Madison Central High School | Football Field Turf & Track Replacement
WBA Project No. 0120

ADDENDUM NO. 01

WORKING NUMBER: —
DRAWING NUMBER: C-1

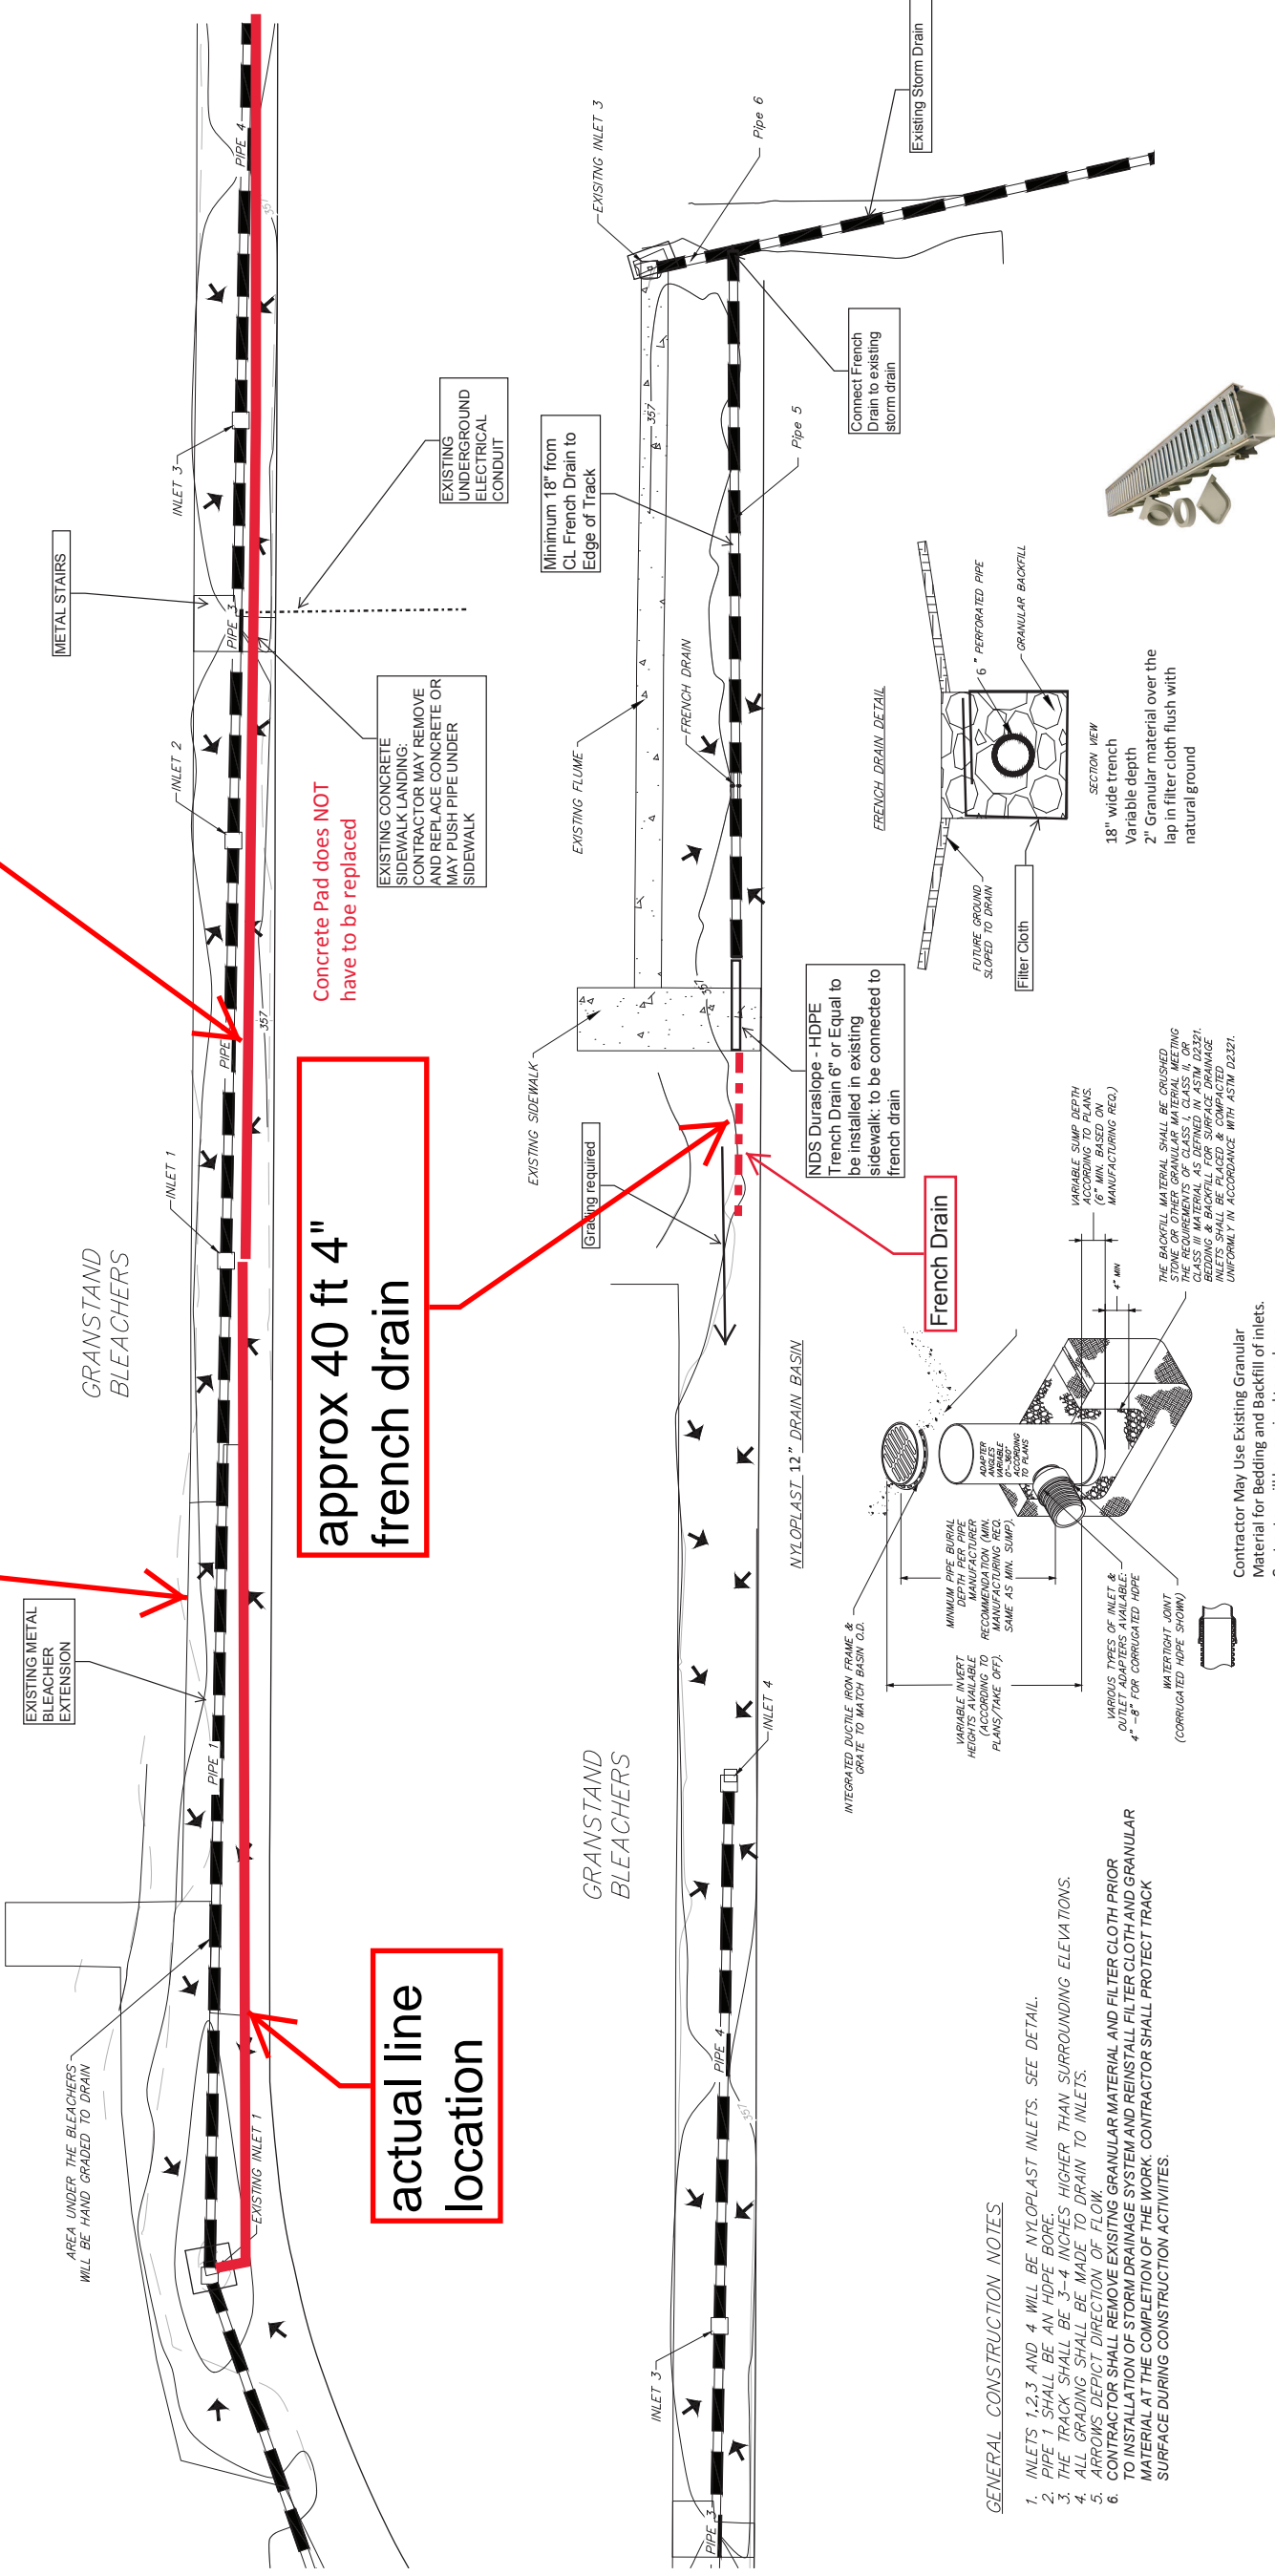
- ITEM NO. 8** **DRAWING A102, Detail 2**
CLARIFICATION: The contractors will need to allow for grading of the existing subgrade in order to achieve necessary drainage as required. The drain shown in the detail, is not a continuous trench drain, but instead a series of drains tied together. The tops of these drains are to be adjusted and lowered (up to 2 inches) in order have them flush out with the surface of the concrete.

See the attached Drawing provided for clarification on the as-built condition of the drainage installation.

line and inlets are a little closer to track edge than we planned

actual line location

approx 40 ft 4" french drain

Concrete Pad does NOT have to be replaced

EXISTING CONCRETE SIDEWALK LANDING CONTRACTOR MAY REMOVE AND REPLACE CONCRETE OR MAY PUSH PIPE UNDER SIDEWALK

Contractor May Use Existing Granular Material for Bedding and Backfill of inlets. Contractor will be required to replace granular material as needed to maintain 2 inch thickness over finished surface
